No. ED24030343-00E

Subject	Spool holder change on KT-S1501CAII and KT-S1501CBIII			
Date Issued	19 <sup>th</sup> Mar 2024	Page	1/2	
Model	Model KT-S1501CAII / KT-S1501CBIII		Mechanical

BAJ Ref: RC0264

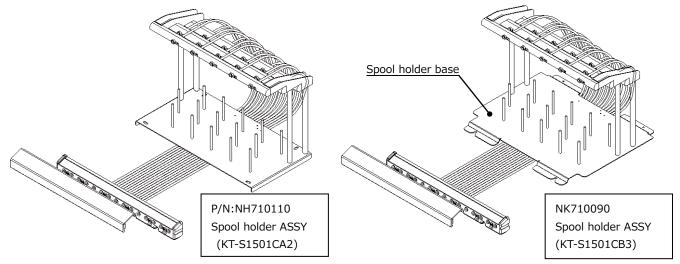
The spool holder ASSY for the KT-CAII and KT-CBIII are different, as seen by the appearance of the spool holder bases shown below.

- 1) Set the spool holder ASSY on the spool holder spacer and attach with (4) M6X12 truss head screws.
- 2) Attach the thread collar base ASSY to the tension ASSY with (4) M3x8 Hex. socket bolts.

- 1) Set the spool holder ASSY on the top cover and attach it with (4) M5x8 truss head screws.
- 2) Attach the thread collar base ASSY to the tension ASSY with (4) M3x8 Hex. socket bolts.
